**AGENDA
PLANNING & ZONING COMMISSION MEETING
CITY OF LEANDER, TEXAS**

7. Conduct a Public Hearing and consider action regarding Comprehensive Plan Case CPA-24-0012 to amend the Transportation Master Plan as set forth in the Comprehensive Plan, Leander, Williamson and Travis Counties, Texas.
 - Discuss and consider action regarding Comprehensive Plan Case CPA-24-0012 as described above.
 - a. Staff Presentation
 - b. Open Public Hearing
 - c. Close Public Hearing

THOROUGHFARE PLAN AMENDMENTS

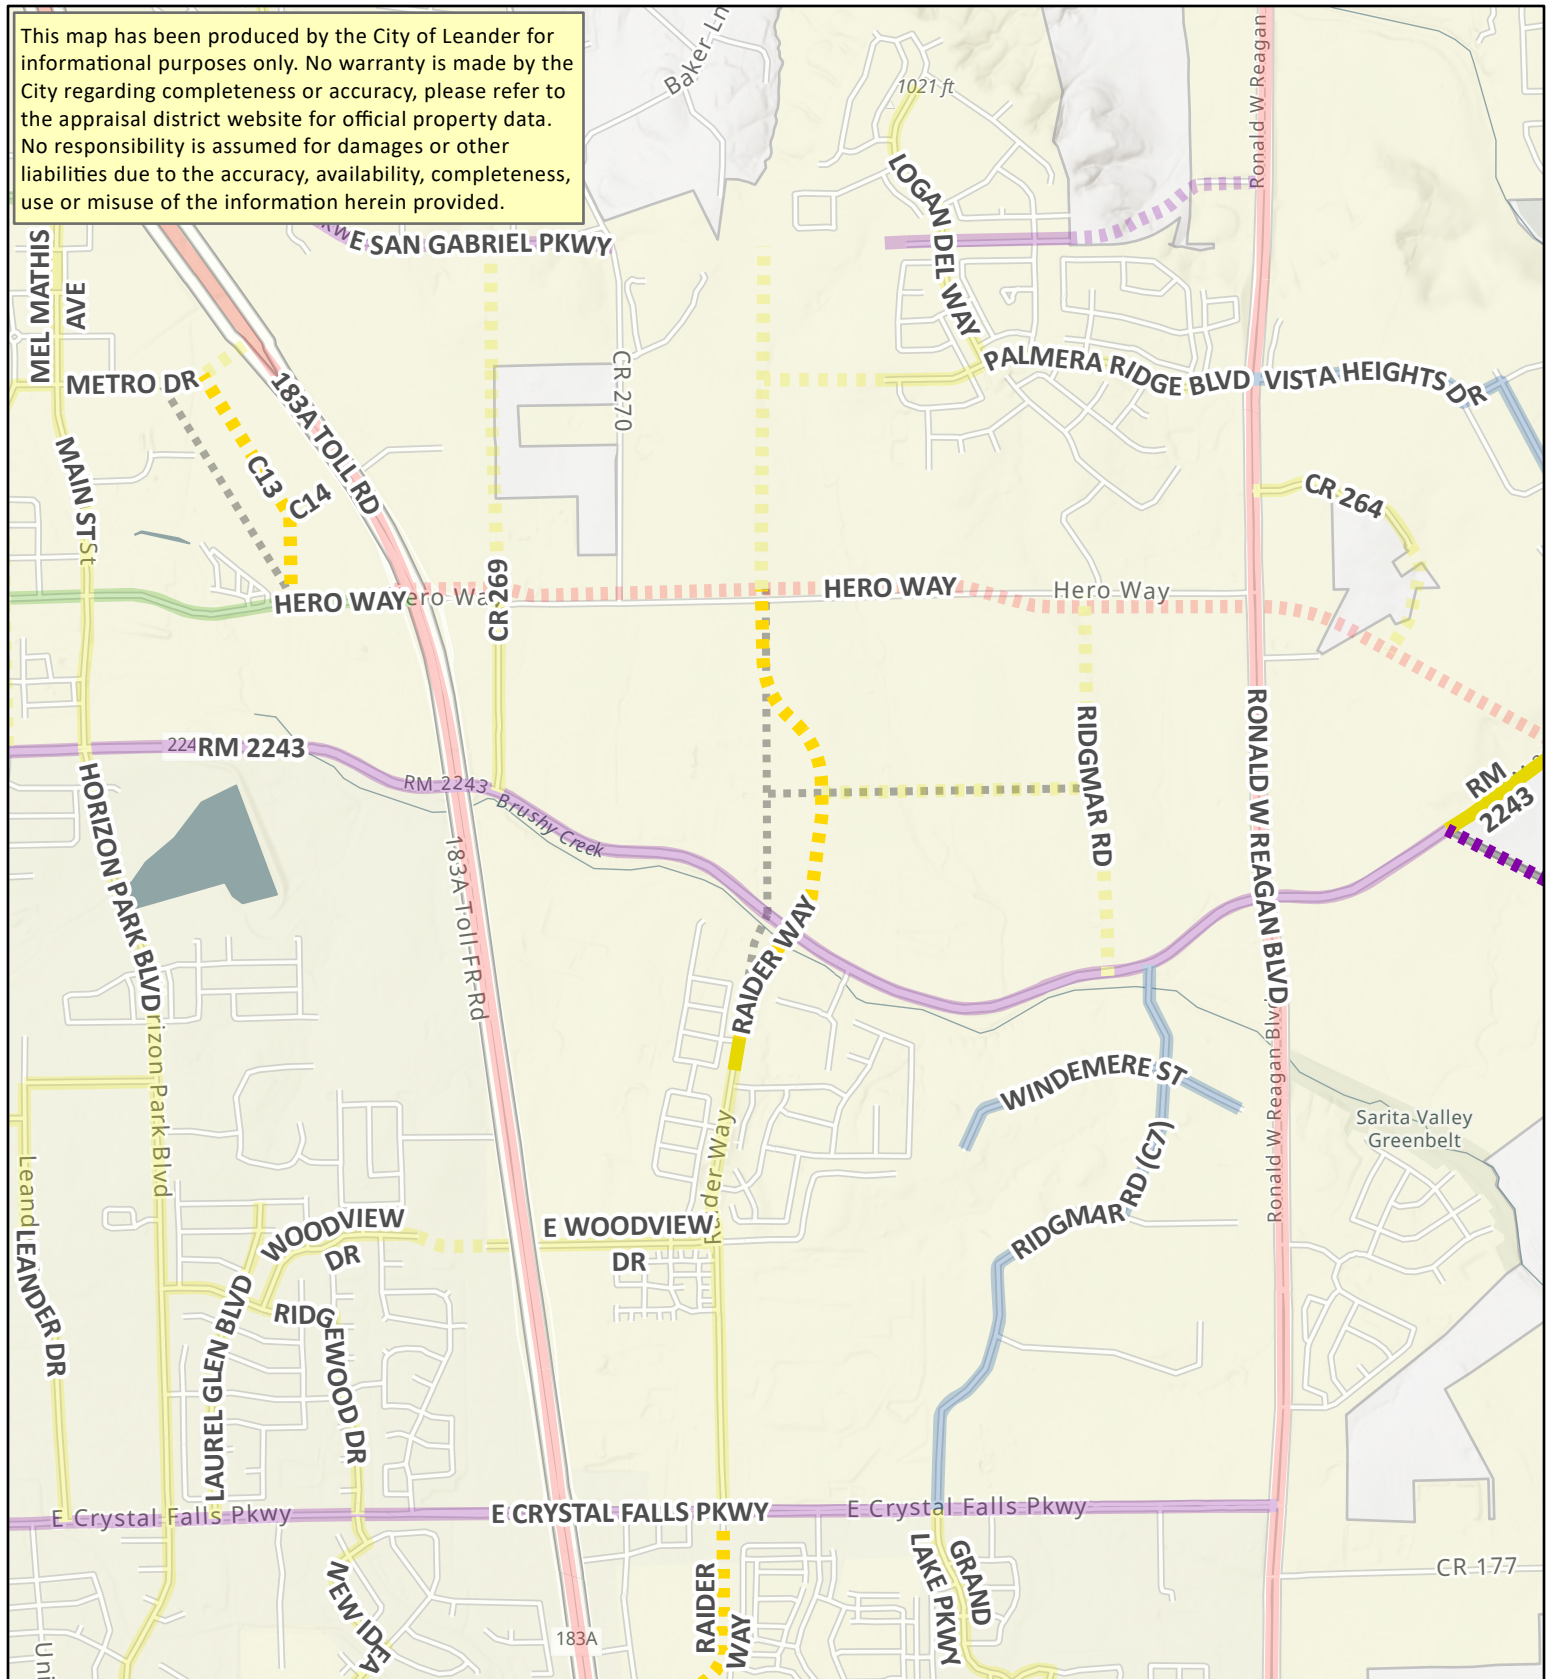
Change Description: CR 175 alignment and tie into New 2243 from County.

THOROUGHFARE PLAN AMENDMENTS

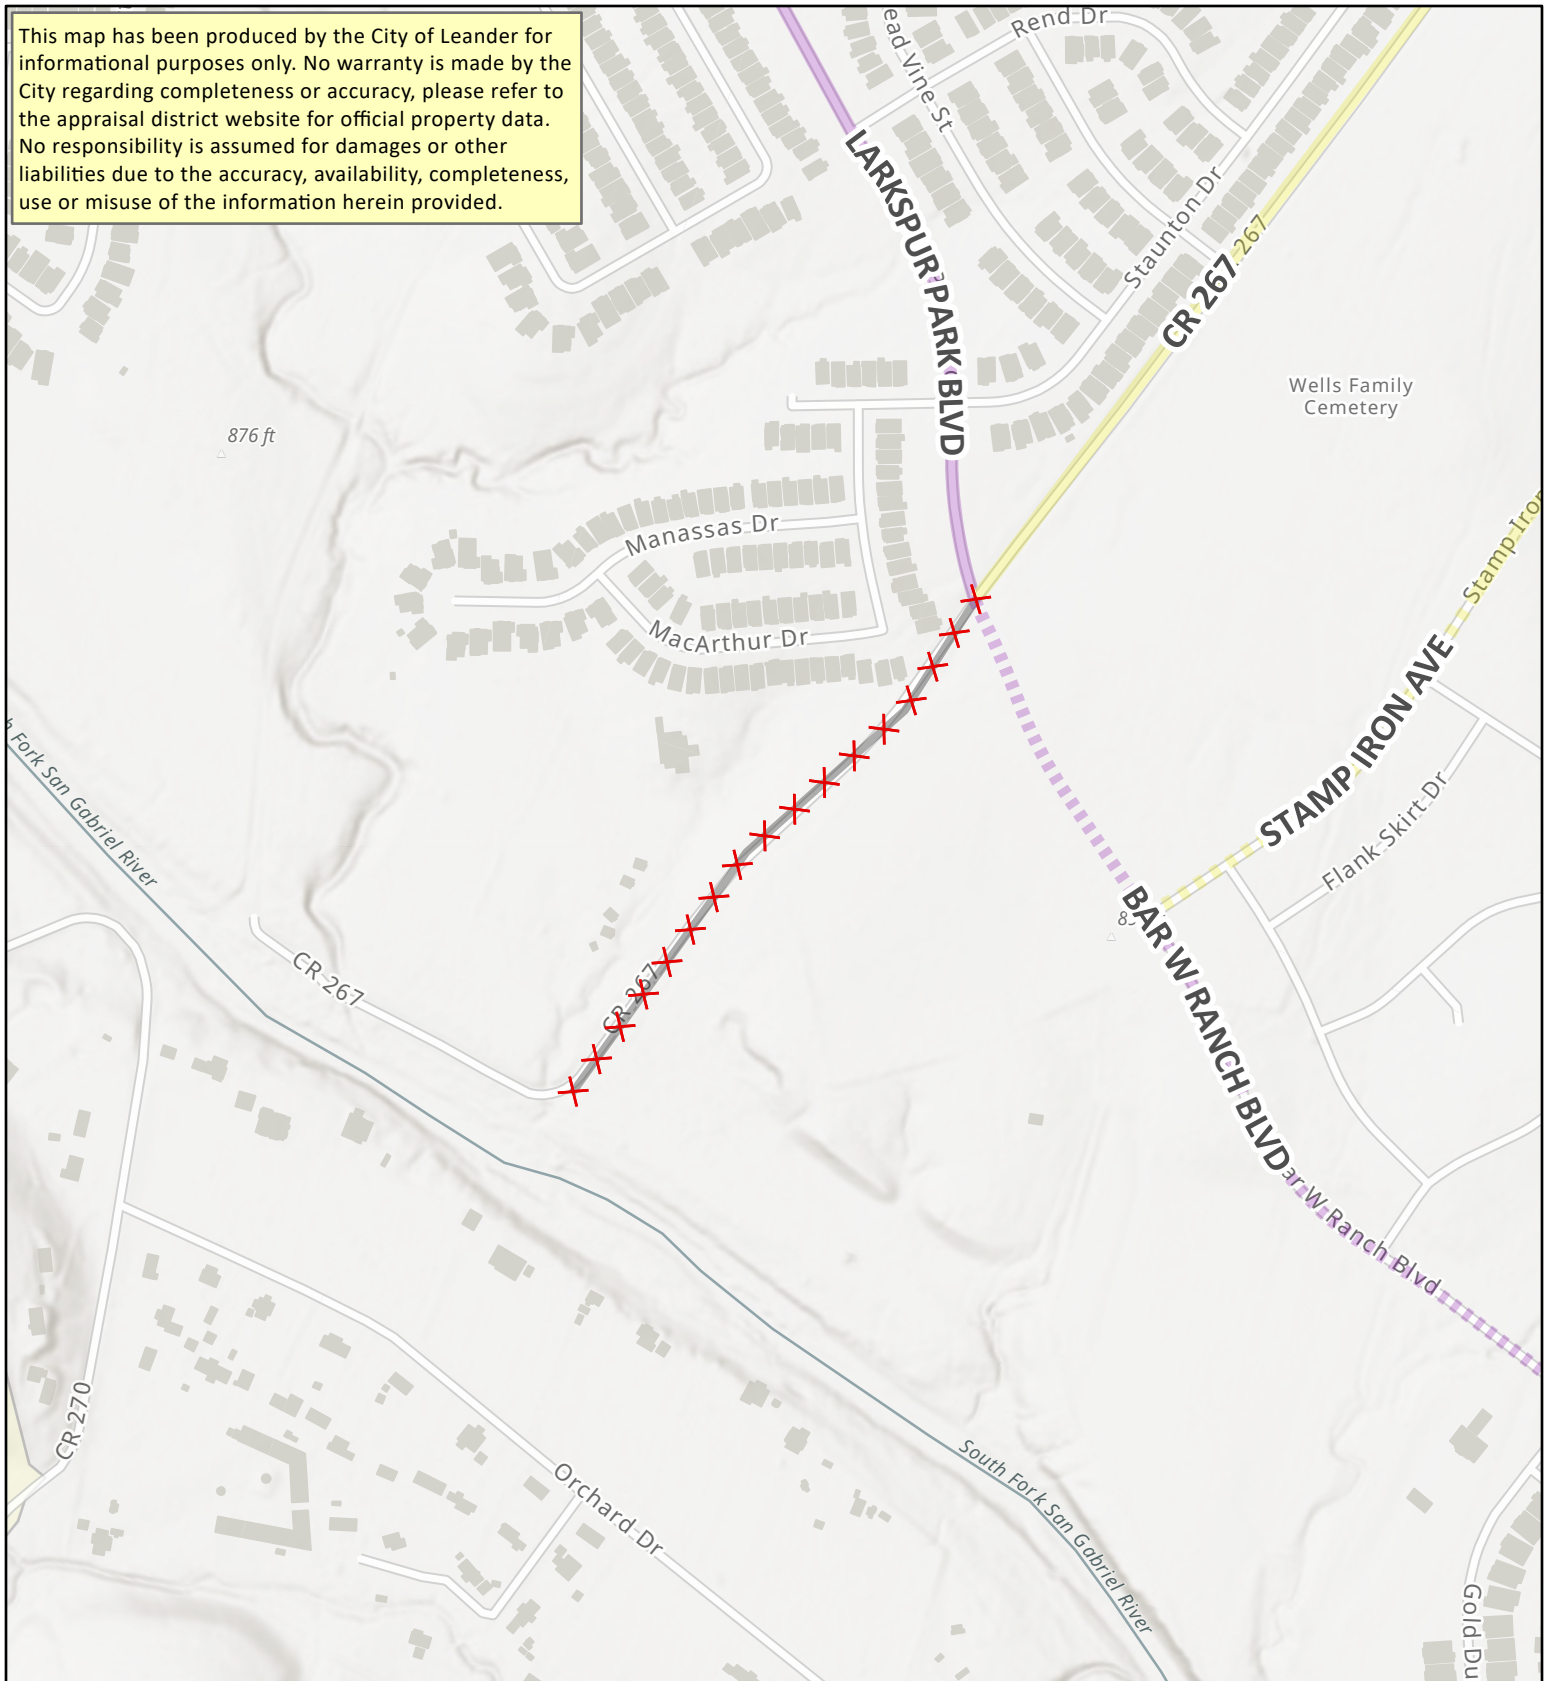
Change Description: Raider Way alignment from Torre to Hero Way from Raider Way Study. (Kimley Horn)

THOROUGHFARE PLAN AMENDMENTS

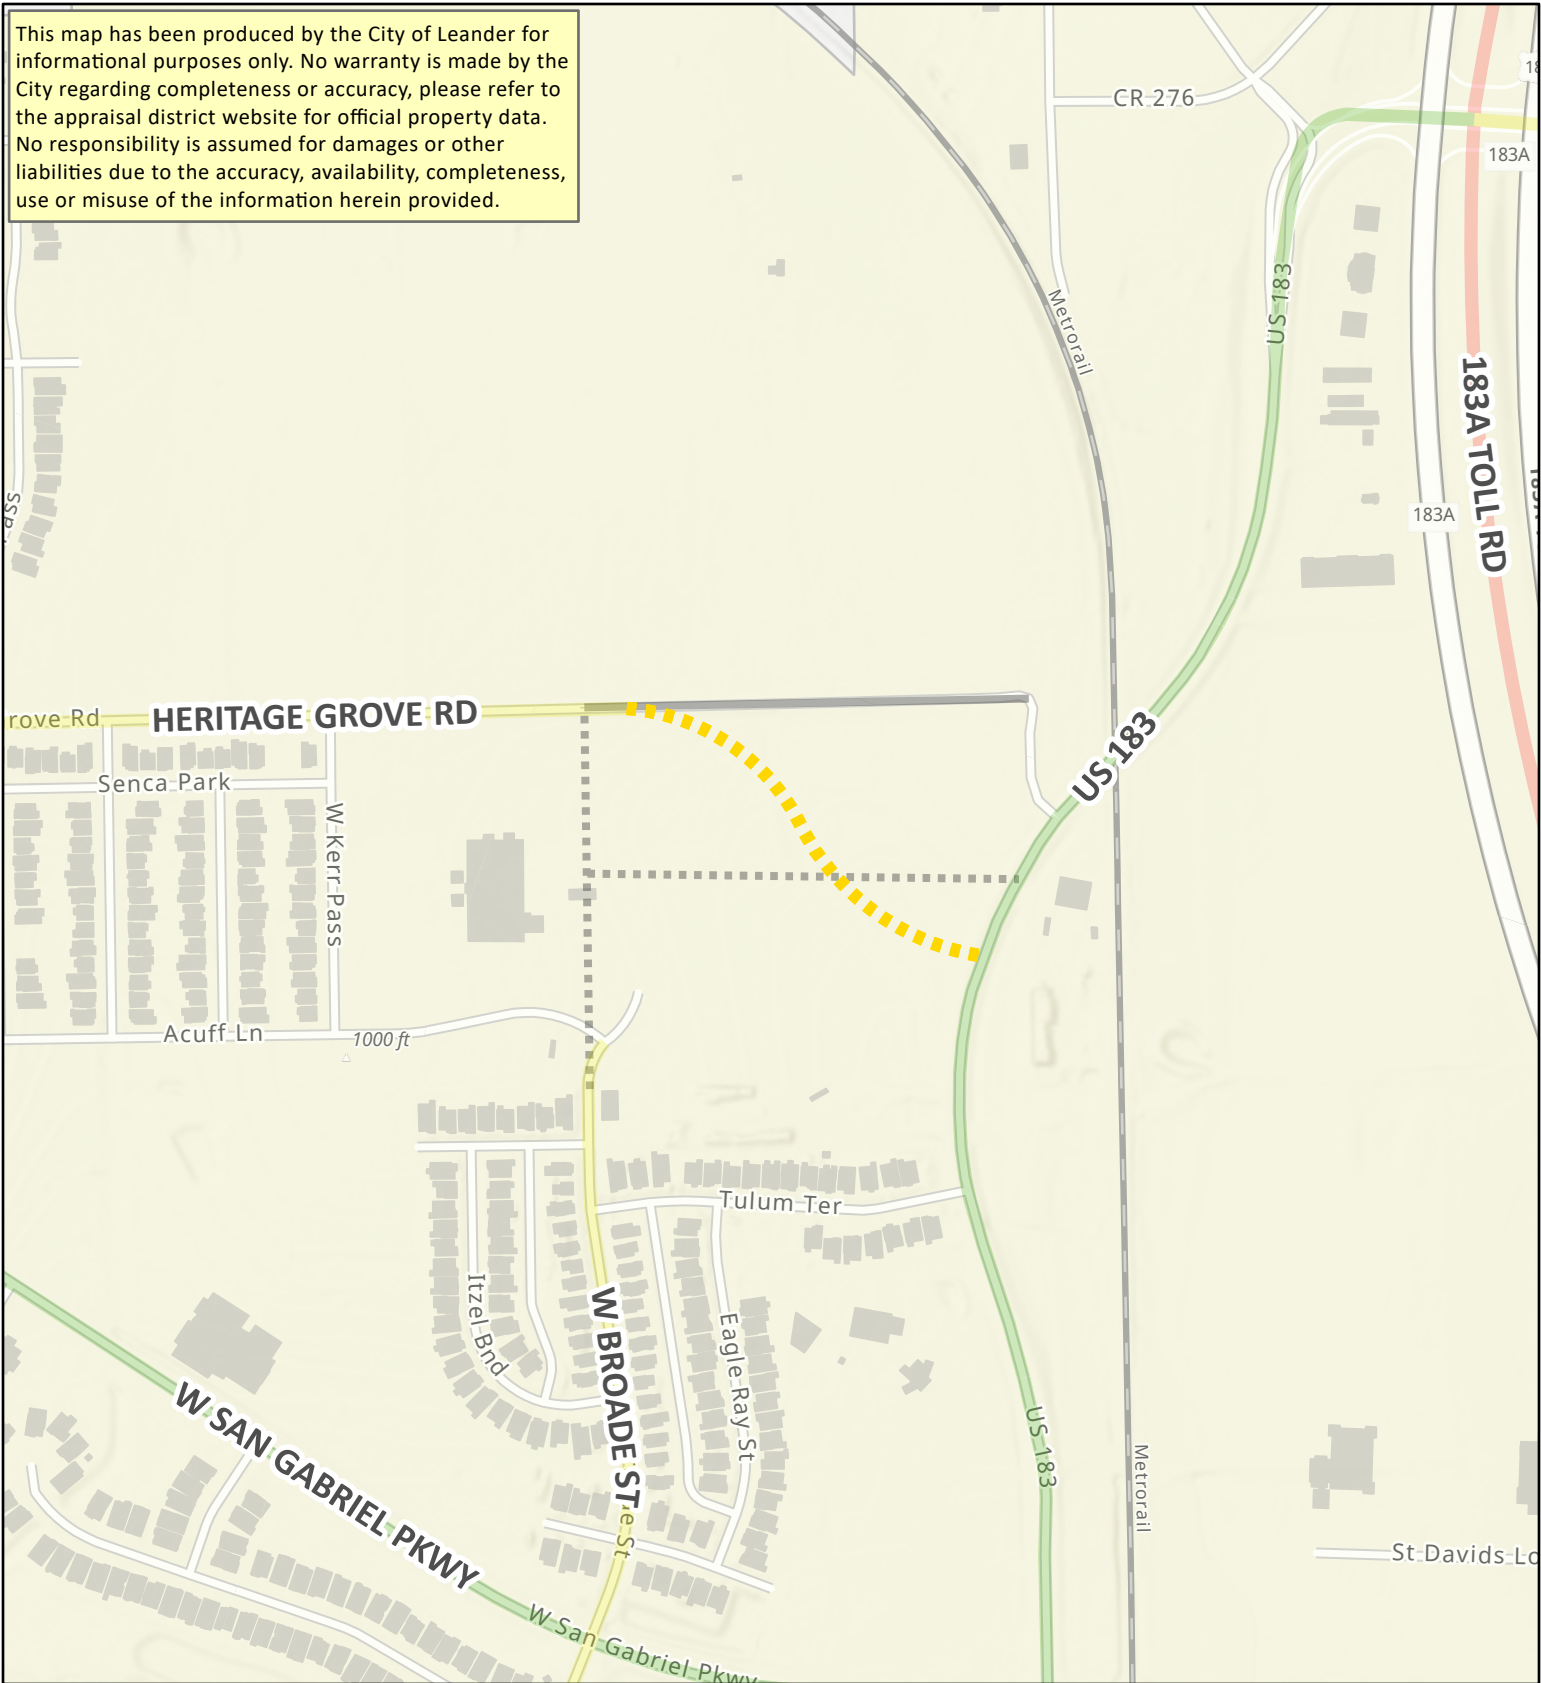
Change Description: CR 267 south of Bar W Ranch Blvd has been vacated and removed from the Thoroughfare Plan.
